APPENDIX B
POST-DR II DESIGN CHANGES

Oregon Square
November 5, 2015

CAMPUS COMMENTS TO ADDRESS - POST DR II

PREFERRED - CLARIFIED SOUTH ENTRY / LOBBY

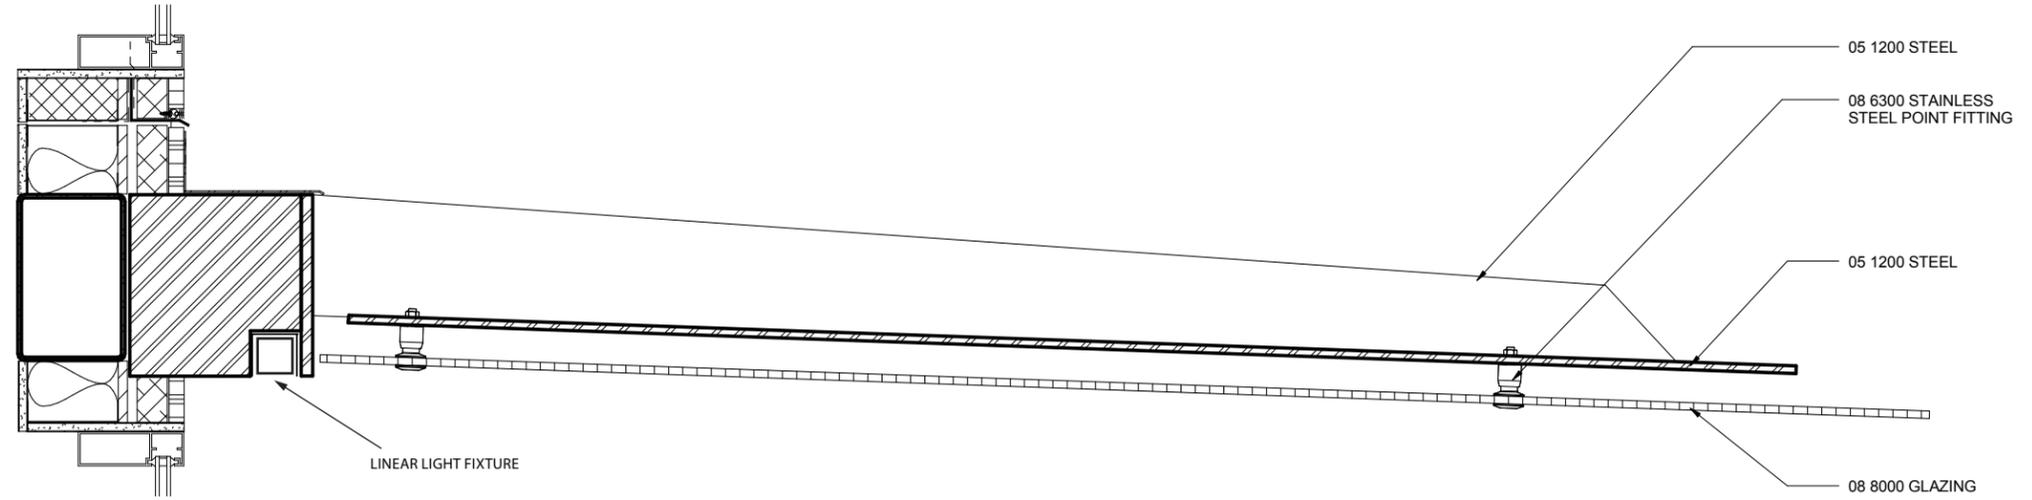
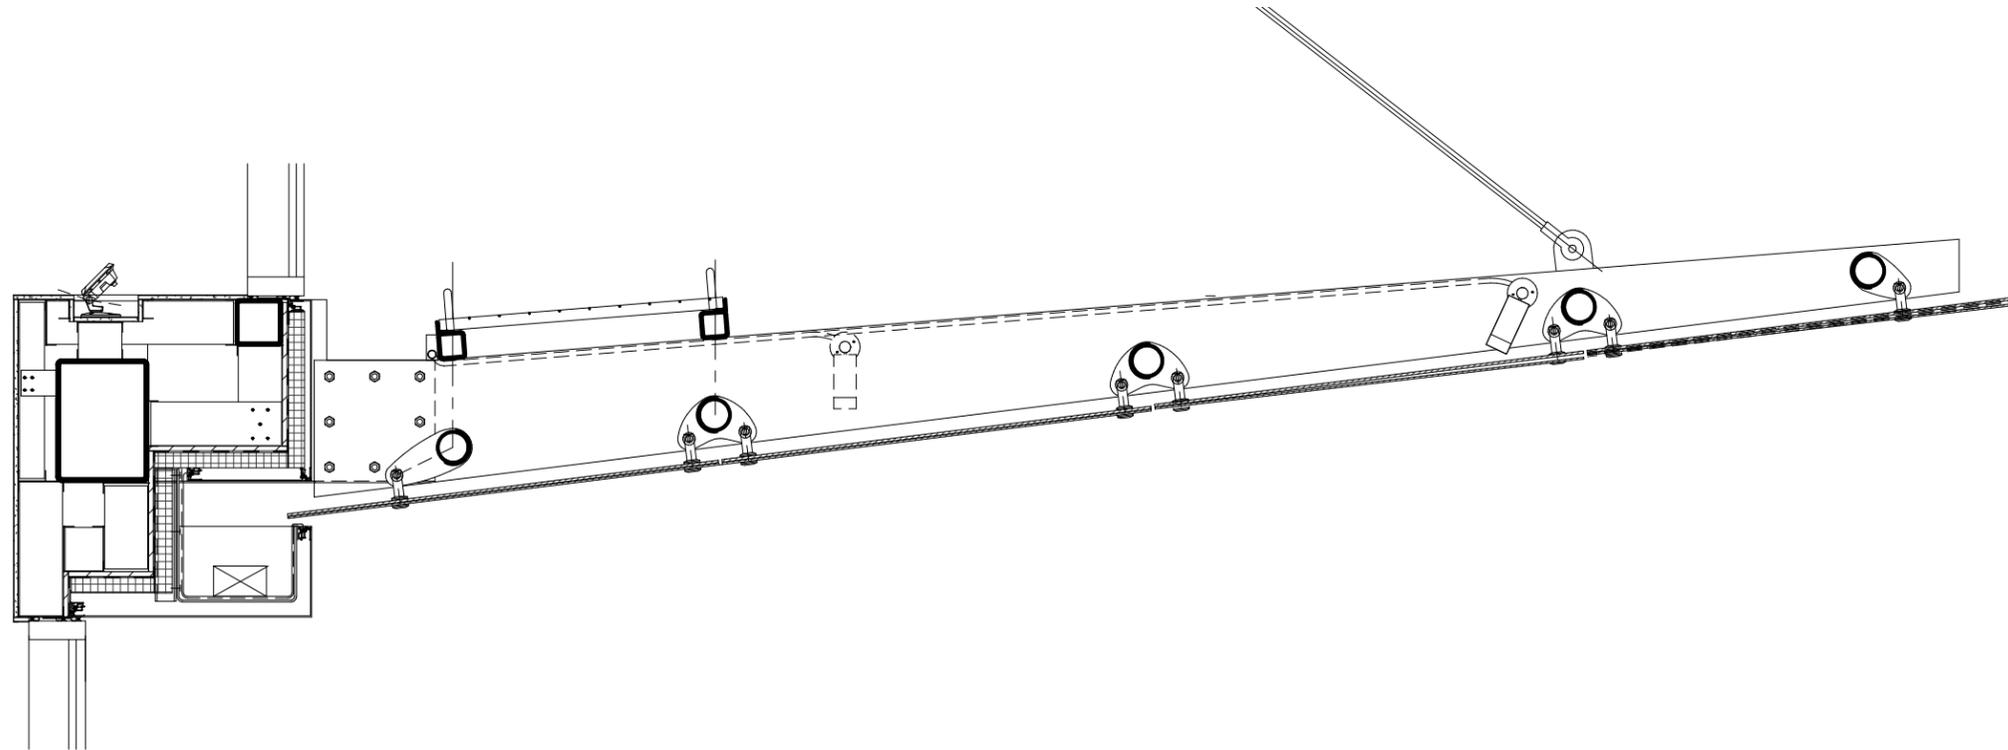
Main building entry is still constricted. Feels forced and tortured.

This lobby is a separate, glassy element that gives clear sightlines into the plaza. The southern lobby entrance wraps around to align with the tower balcony wall, allowing room to internalize the ramp and keep the entry on grade with the sidewalk.

GARAGE ENTRY WALL GRAPHIC CONCEPTS

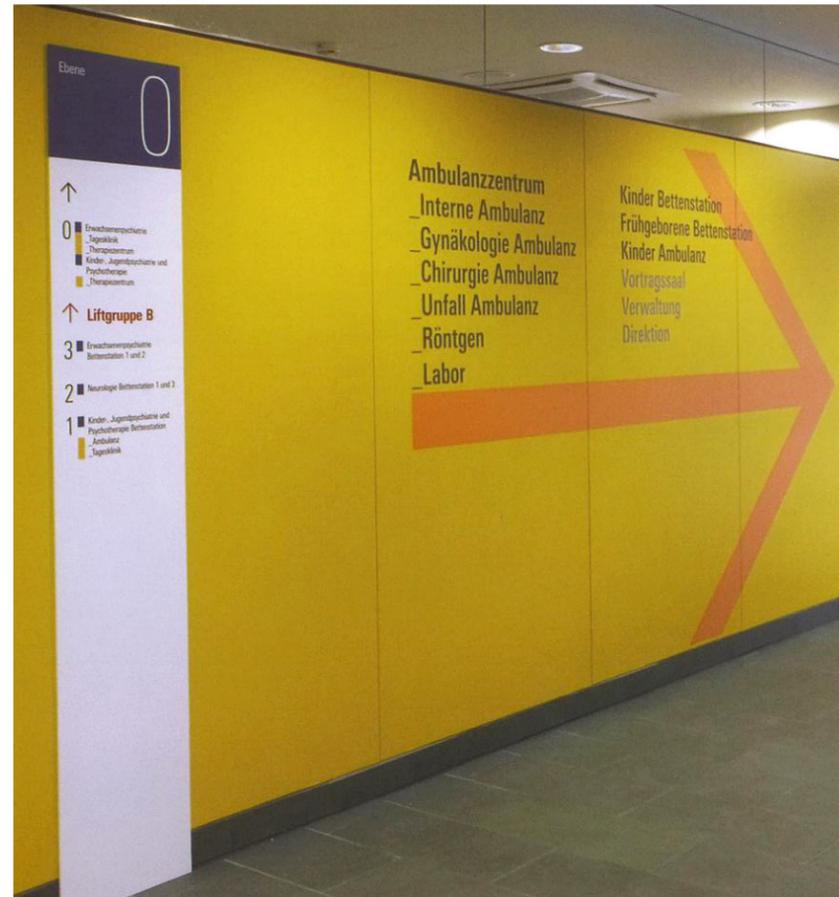
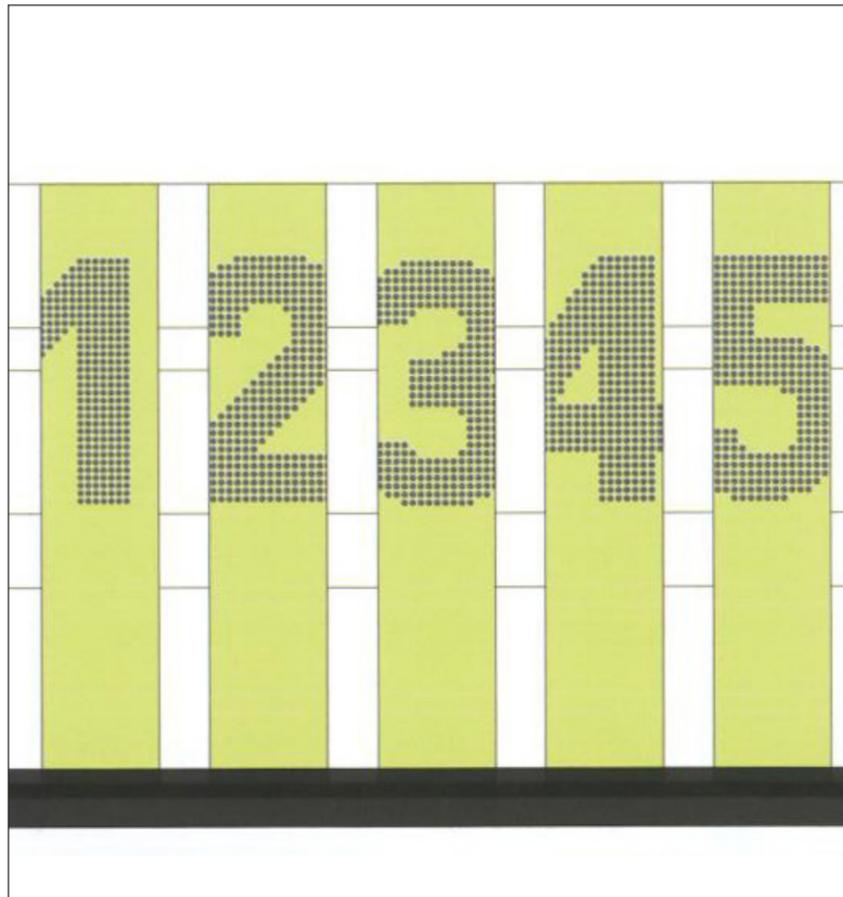
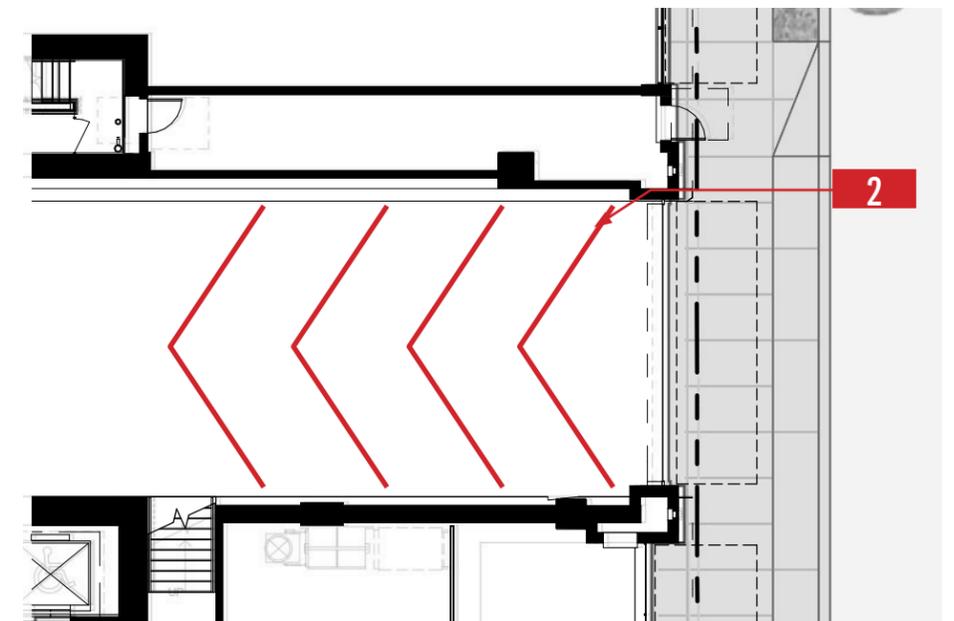
Provide elevations of interior walls of both garage entries to show lights and graphics.

This imagery represents the design intent for the graphics and signage on the garage entry walls. These are similar to what was used in phase 1 (Hassalo on eighth); We do not want to be held to these specific graphics, but rather the intent shown in this imagery.
